**Reference: Corrective Action Plan Amendment**  
Edgecombe County Landfill  
Tarboro, North Carolina  
S&ME Project No. 1054-07-241A

CORRECTIVE ACTION PLAN AMENDMENT  
Edgecombe County Landfill  
(Permit #33-01)  
Tarboro, North Carolina  
S&ME Project No. 1054-07-241A

**PROPOSED HYDRAULIC BARRIER**  
 CORRECTIVE MEASURES DESIGN  
 EDGECOMBE COUNTY LANDFILL  
 TARBORO, NORTH CAROLINA

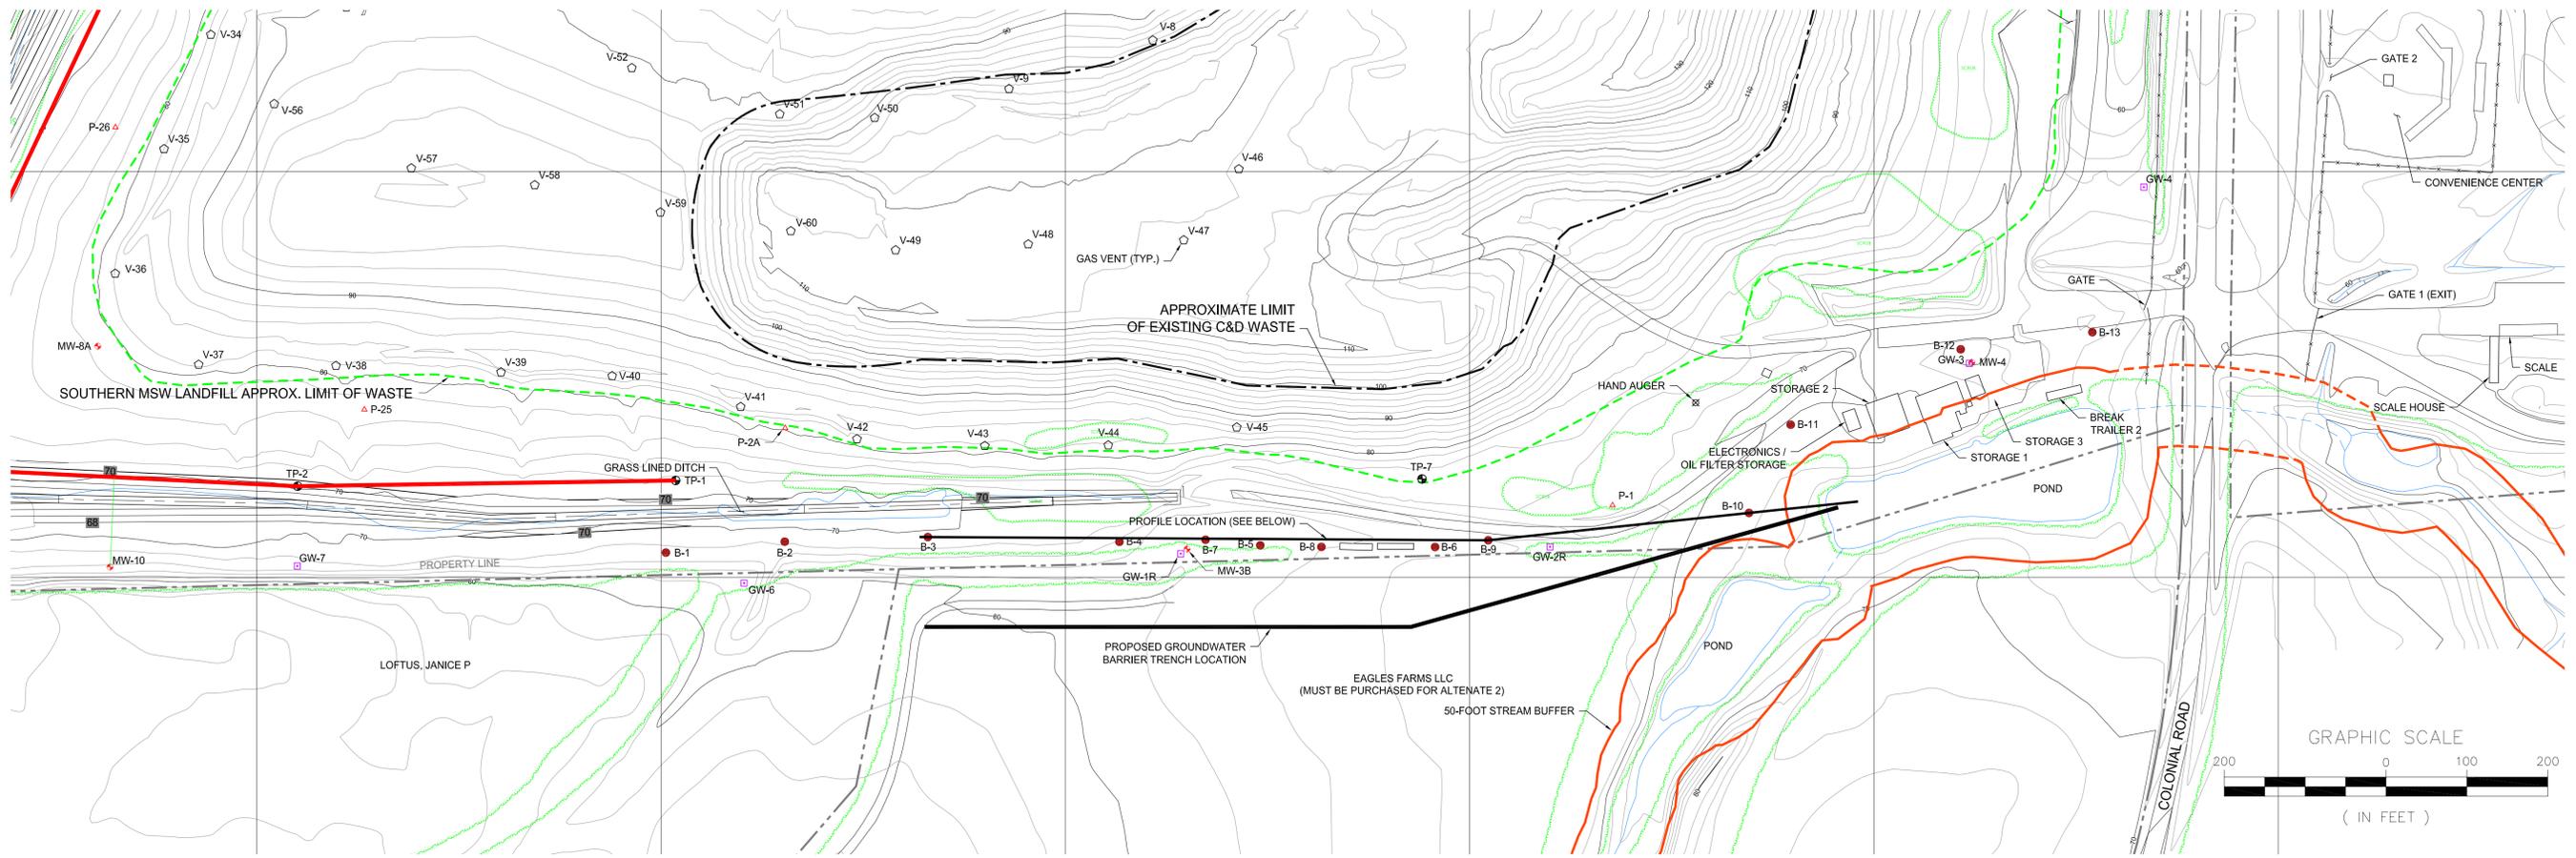
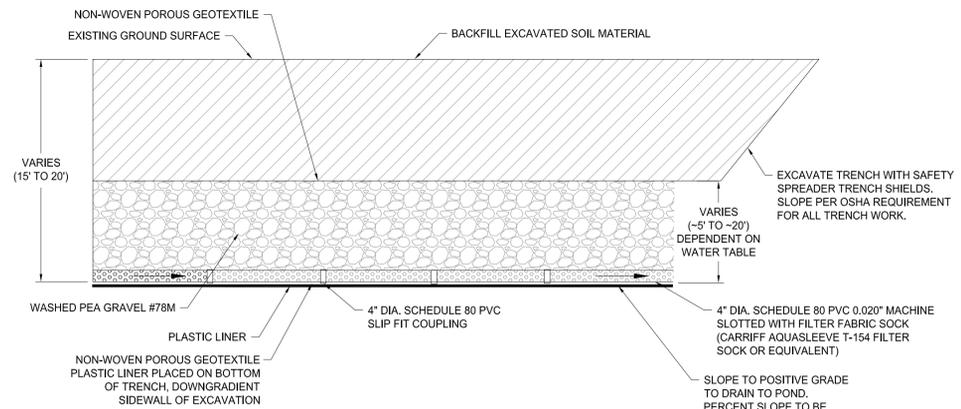
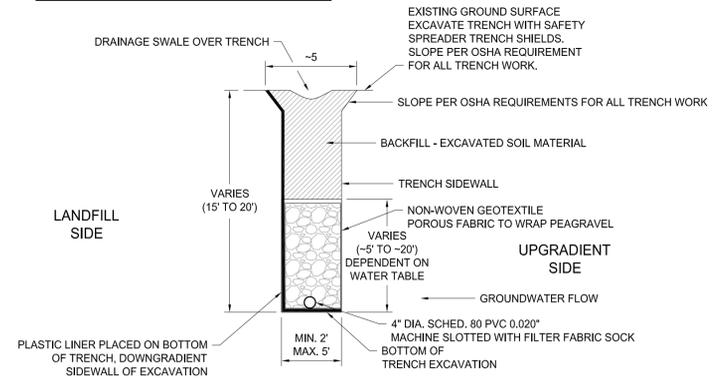
Edgecombe County reviewed the four hydraulic barrier system options developed by S&ME for the proposed corrective measures. Based on the options review a hydraulic barrier that would utilize an interceptor trench drain in tandem with dewatering the pond on the southeast corner of the property (Option 4) was selected as the preferred design for implementing the hydraulic barrier system.

Option 4 includes dewatering the existing drainage ditch and pond features and installing a groundwater barrier trench drain to form a hydraulic barrier. Option 4 eliminates the subsurface sheet-pile barrier wall (Options 1 and 2), limits long term maintenance compared to an open ditch (Option 3), and retains access to the former Eagles Farm property. Option 4 will require revision to the erosion and sedimentation control permit due to additional area disturbed and will require coordination with NCDENR DWQ for a riparian buffer encroachment and NPDES permit requirements. Significant design features include the following:

- Re-design the outfall structure that regulates the flow through the ponds or remove the dam to the pond located on the southeast corner of the facility;
- Install 1,150 linear feet of groundwater barrier trench drain on the former Eagles Farm LLC property to direct groundwater to the existing pond to the east and/or drainage ditch to the west;

The location of the proposed hydraulic barrier system described in Option 4 is presented on **Figure 3**. **Figure 3** also presents a profile that depicts the ground surface; the top of the Yorktown Formation; the proposed groundwater barrier trench invert, and construction details for the hydraulic barrier trench. The hydraulic barrier proposes to block and divert groundwater above the Yorktown marine clay from flowing beneath the landfill. By retaining and/or diverting the groundwater from flowing beneath the landfill, the volume of water available for the production of leachate and/or the transport of leachate will be reduced. The reduction of groundwater flow beneath the landfill will also lower groundwater levels within the landfill.
